**FINDINGS AND RECOMMENDATION
OFFICE OF PLANNING AND ZONING
ANNE ARUNDEL COUNTY, MARYLAND**

CASE NUMBER: 2025-0004-V

The applicants are requesting variances to allow a dwelling addition (carport) with less setbacks and buffer than required and with disturbance to slopes of 15% or greater on property located at 600 Tower Bank Court in Severna Park.

SITE DEVELOPMENT PLAN

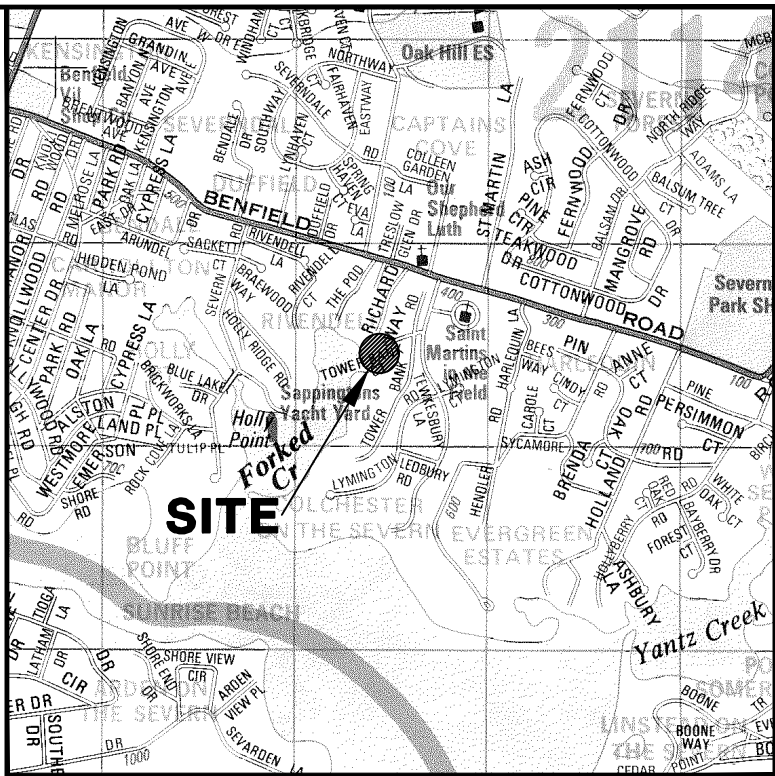
The proposed construction will disturb slopes of 15% or greater, necessitating a variance. The final amount of disturbance will be determined during permit review.

The proposed construction will disturb the expanded buffer, necessitating a variance. The final amount of disturbance will be determined during permit review.

The proposed carport would be constructed as close as 15.79 feet to the corner side lot line, necessitating a variance of 25 feet.

The site plan will need to dimension the distance between the proposed addition and the corner side lot line so a variance distance can be determined. The existing dwelling height and addition height should be clearly labeled on the site plan. The applicant should provide additional justification on why the size of the carport is being increased and how this increased size represents the minimum necessary.

- **approval** of a Critical Area variance to § 17-8-201 to disturb steep slopes;
- **approval** of a zoning variance to § 18-13-104 to allow disturbance to the expanded buffer; and,
- **approval** of a zoning variance to § 18-4-501 to allow a dwelling addition with less setbacks than required.

Our response: Noted
